# 1989 Corvette: Service Bulletin: Tire Rotation Procedure

**Subject:** Tire Rotation Procedure  
**Model and Year:** 1989 Y Car with Optional Low Tire Pressure Warning System  
**Source:** Chevrolet Dealer Service Bulletin  
**Number:** 89-299-3E  
**Section:** 3E  
**Date:** February 1990

**Corporate Bulletin No:** 013501

Figure 1 - Tire Rotation Pattern

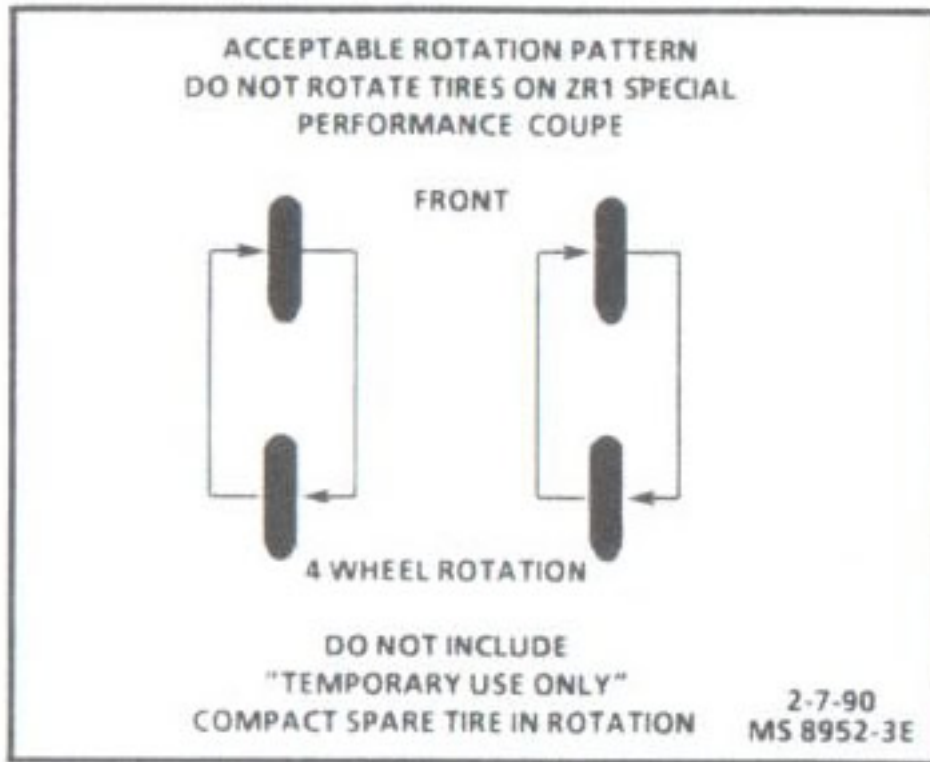
The Low Tire Pressure Warning System receiver does not recognize wheel/tire assembly location; however it does look for a particular signal from each of the four wheel transmitter/sensors. Therefore, the procedure given on the tire rotation in Section 3E of the 1989 "Y" Carline Service Manual should be disregarded. The tire and wheel assemblies on vehicles equipped with the optional Low Tire Pressure Warning System can be rotated as show in Figure 1.
